**Parts List and Diagram for Morse Kit # 5017KIT-P**

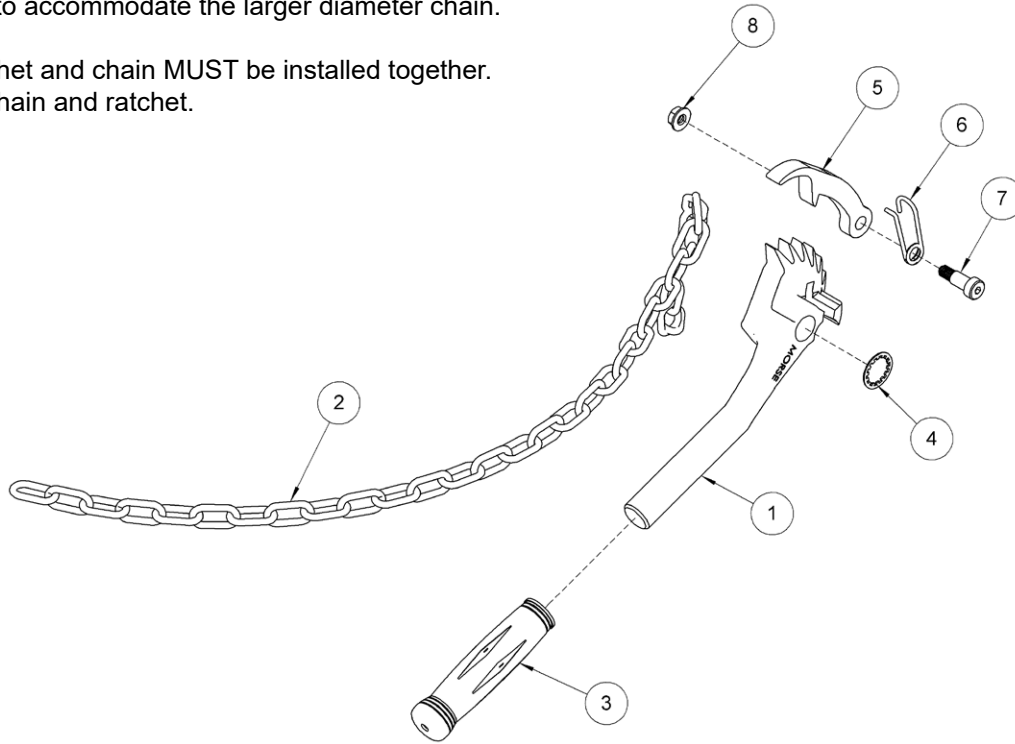
This kit is required to replace the 3/16 alloy cinch chain (part # 180-P) and ratchet (part # 165-P) on Morse drum holders. The 3/16 chain is no longer available and has been replaced by a 9/32 alloy chain. The ratchet (part # 165-P) needs to be replaced in order to accommodate the larger diameter chain.

Replacement ratchet and chain **MUST** be installed together. Discard existing chain and ratchet.
